Access Compliance Report

Public Rights-of-Way

Intersection ID: 46745	Main Street: CUMBERLAND_COVE_DR	Cross Street: NORMANS_LANDING_DR	Location: NE
ADA ID: 4ED698AFDEF6	Ramp Type: PerpDiag	Initial Pass/Fail: Fail	Overall Compliance: No
Codes/Mitigation Info/Possible Solution		Field Measurements/Component Compliance	
Severity Score: 33.75

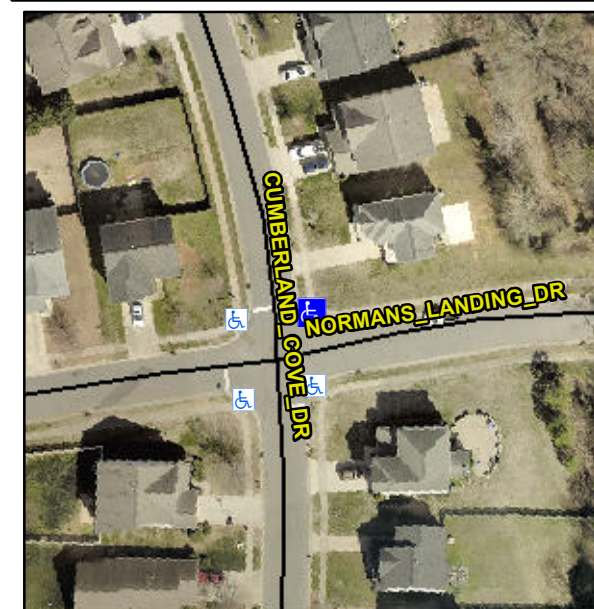
R304.5.1, R304.5.3

Compliance	Description	Data	Compliance	Description	Data
N/A	Ramp Length (in)	48.0	Yes	Ramp Slope (%)	5.9
No	Ramp Width (in)	45.5	No	Ramp XSlope (%)	8.3
N/A	Flare Type LT	N/A	N/A	Flare Type RT	N/A
N/A	Flare Slope LT (%)	N/A	N/A	Flare Slope RT (%)	N/A
N/A	Flare Traversable LT?	N/A	N/A	Flare Traversable RT?	N/A
N/A	Landing Length (in)	N/A	N/A	DWS Provided?	N/A
N/A	Landing Width (in)	N/A	N/A	DWS Contrast?	N/A
N/A	Landing Slope (%)	N/A	N/A	DWS Length (in)	N/A
N/A	Landing X Slope (%)	N/A	N/A	DWS Full Width?	N/A
N/A	Landing Curb? (Y/N)	N/A	N/A	DWS Offset (in)	N/A
N/A	Shared Landing?	N/A			
N/A	Gutter Ponding?	N/A	N/A	Gutter Slope (%)	N/A
N/A	Gutter Lip Ht (in)	N/A	N/A	Gutter X Slope (%)	N/A
N/A	Painted X Walk1?	No	N/A	Painted X Walk2?	No
	X Walk 1 Direction	To W		X Walk 2 Direction	To S
N/A	X Walk 1 Width (in)	N/A	N/A	X Walk 2 Width (in)	N/A
	X Walk 1 Slope (%)	6.6		X Walk 2 Slope (%)	0.6
	X Walk 1 X Slope (%)	1.6		X Walk 2 X Slope (%)	6.3

Remove & Replace Curb Ramp With Two New Directional Ramps or Equivalent.
